CNL-14-007

Watts Bar Nuclear Plant, Unit 1
Facility Operating License No. NPF-90
NRC Docket No. 50-390

Watts Bar Nuclear Plant, Unit 2
Construction Permit No. CPPR-92
NRC Docket No. 50-391

Subject: Follow-up Response to NRC Request for Additional Information Related to Overall Integrated Plan in Response to the Commission Order Modifying Licenses with Regard to Requirements for Reliable Spent Fuel Pool Instrumentation (Order Number EA-12-051) (TAC Nos. MF0951 and MF1178)

Sketch 1

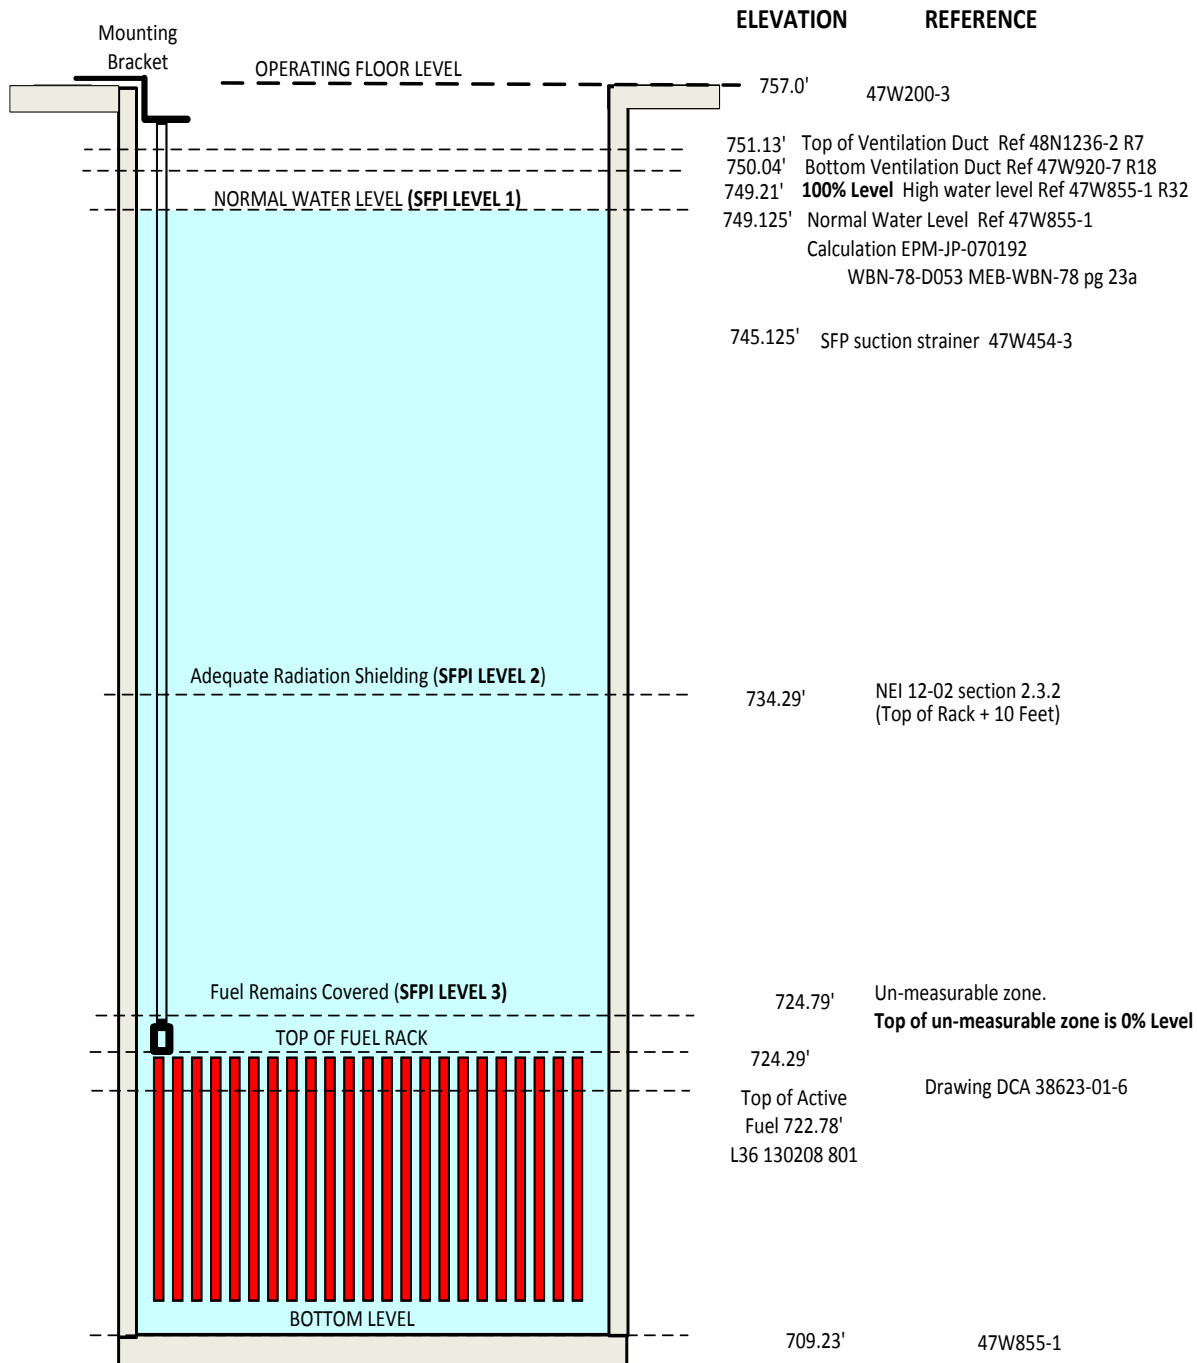
During the December 19, 2013, teleconference call, clarification was requested regarding throttling of pump discharge as discussed in response to RAI question 1. Information has been added to the response as underlined below to address this clarification. Sketch 1 has also been revised to include the top and bottom vent elevations as shown. This revised response and Sketch 1 supersede those submitted in the referenced letter.

Please provide the results of the calculation used to determine the water elevation necessary for the pump's required NPSH to confirm that Level 1 has been adequately identified.

Watts Bar Nuclear Plant (WBN) calculation EPM-JPJ-07-192 documents adequate net positive suction head (NPSH) at elevation 749.125 feet (normal pool level) for Spent Fuel Pool (SFP) temperatures up to 190 degrees Fahrenheit (F). Refer to Sketch 3 on page E1-23. During a BDB-EE, as temperatures rise above 190 degrees F, WBN will control by procedure the throttling of pump discharge to ensure adequate NPSH. The calculation detailing this throttling requirement for BDB-EE has not been issued at this time. WBN has documented this action in the Corrective Action Program Problem Evaluation Report (PER) 770244 and the scheduled completion of calculation and procedure update is by February 21, 2014. Throttling is required because the level 1 reference elevation cannot be raised to provide adequate NPSH above 190 degrees F since ventilation ductwork is approximately 0.8 feet (elevation 750.04 feet) above the existing 100% level (refer to Sketch 1). Access to SFP pumps, heat exchangers, and valves can be achieved from the Shutdown Board Room, shown in sketch 1, on elevation 757 through the Auxiliary Building access point and down the central stairway to elevation 737 or from the Auxiliary Building access point on elevation 713 and up the north or central stairway to elevation 737. Valves that would require manipulation based on which train of SFP cooling is being restored are located in the center south area of elevation 737.
